# 17-096ARB-MPR – 113 S. HIGH STREET

**Request**

Request for a proposed ±3,300-square-foot two-story office building and associated site improvements; parking plan; and fee-in-lieu of open space.

**Staff Recommendation**

### 3. Site Plan

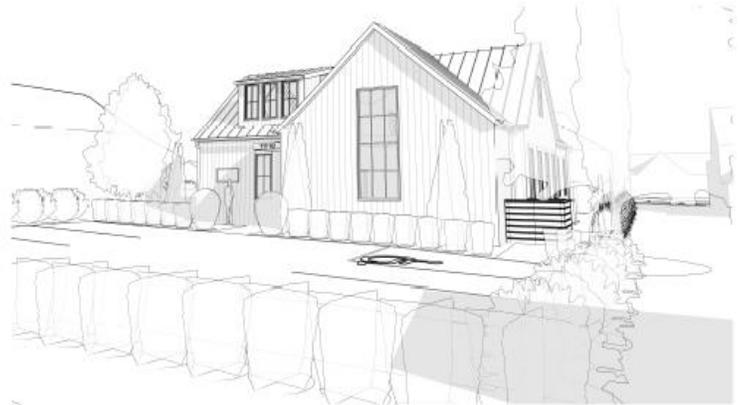
The proposed site layout includes two buildings on one lot with frontage on South High Street to the east and Mill Lane to the west. The proposed building is located to the rear of the existing historic structure, in between a parking lot and the existing building. There is a separation of ±19.5 feet between the two buildings. A shared concrete walkway from the parking lot would connect the two buildings. A

landscaped area would provide separation between the buildings and a landscape buffer is provided along the northern property line. A 7-space, hard-surfaced parking lot is proposed at the rear of the lot with direct access from Mill Lane. The total site coverage is proposed at  $\pm 65\%$ , where a maximum of 75% is permitted. The proposed development does not incorporate walls or fences. In regards to the Historic Dublin Design Guidelines, the proposed layout conforms to the criteria for placement and orientation on the lot in that the proposed new structure is free-standing, has the same orientation as the existing structure on the site with consistent side yard setbacks, and is located to the side or rear of the existing building.

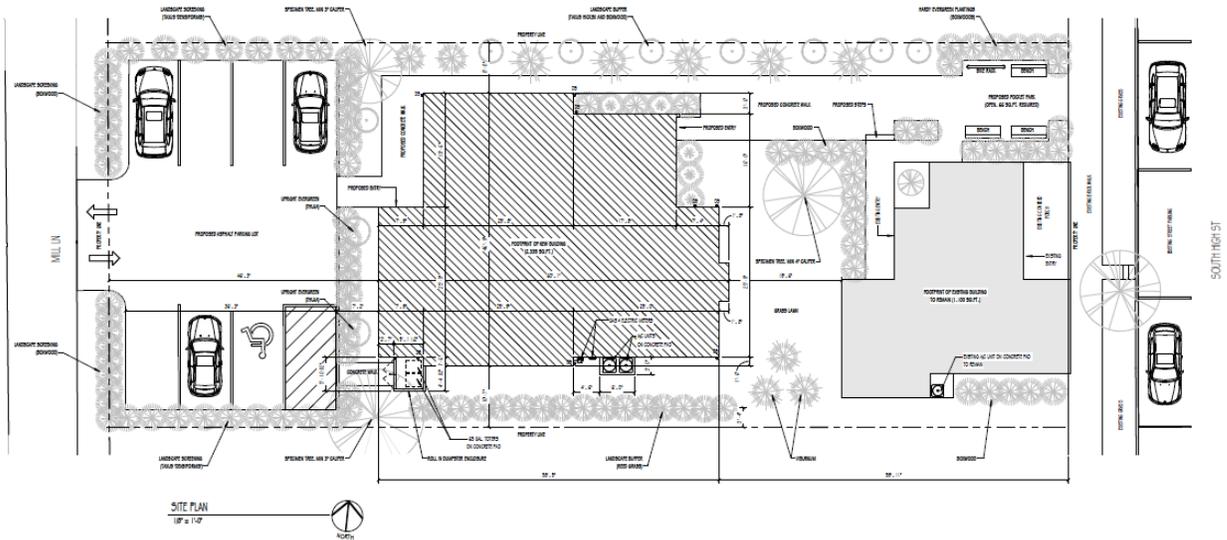
The proposed building is one and one-half stories with a gable roof line and dormers at the east and west elevations. A covered entrance is proposed at the east building entry at a pitch of 0.5:12 where a pitch greater than 3:12 is required on roofs of dormers, porches, balconies, or other minor roofs. The reduced pitch provides a functional covered entrance and maintains a clean line for the contemporary aesthetic of the building. Code requires that all principal entrances be at a pedestrian scale, effectively address the street and be given prominence on the façade through the use of architectural features. A waiver is requested to the northeast and northwest entrances, because they do not address South High Street and Mill Lane, respectively. Due to the building set back behind the existing principal structure, the northeast and northwest entrances are set back from the two streets. In order to accommodate the parking area and reduce the impact on the adjoining property owners, the building was located to the center of the lot.

Materials include shiplap cedar wood siding in dark gray, split-faced concrete masonry base, with horizontal wood accents. Split-faced concrete masonry is not a permitted material within the Historic District. A condition of approval requires that the applicant replace the proposed split-faced block on the lower portion of the proposed building with brick or stone. The shiplap siding and a cultured stone fireplace are contemporary interpretations of wood and stone that have been used in other new construction in the area. A black standing seam metal roof will match the existing building's roof. The east elevation features a prominent stone chimney

and the west elevation has a two-story window at the gable end. Code requires façades be designed to follow the stories of the building with fenestration organized along and occupying each floor. A waiver is requested to allow for the gabled portion of the west elevation to feature a large window which spans the first and second stories. The design of the two-story window adds to the transparency requirement and creates a residential aesthetic which is generally more complementary in this part of the Historic District.

The rhythm of the openings in the proposed building is consistent with that of nearby buildings. Additionally, the proposal is for a cottage-commercial building, with general office uses in the ground story and half story. These uses and the style of building proposed will typically have a lower window to wall ratio than retail or other commercial uses, due to the need for privacy associated with these uses. The window to wall ratio proposed is also appropriate to the style of architecture proposed. As proposed, an administrative departure would be required for the non-street side transparency on the south elevation to allow for  $\pm 14\%$  transparency where 15% is required. Street-facing façades require a minimum of 25% transparency. The applicant is requesting a waiver to allow for  $\pm 10\%$  transparency on the west elevation (Mill Lane).

- 1) That the applicant replaces the proposed split face block on the lower portion of the proposed building with brick or stone.
- 2) That the applicant shall pay a fee-in-lieu of open space prior to building permit approval.
- 3) That the applicant provides required bicycle parking on site.
- 4) Should any archeological resources be identified during excavation, the applicant shall make a reasonable effort to record, protect, and preserve these resources.
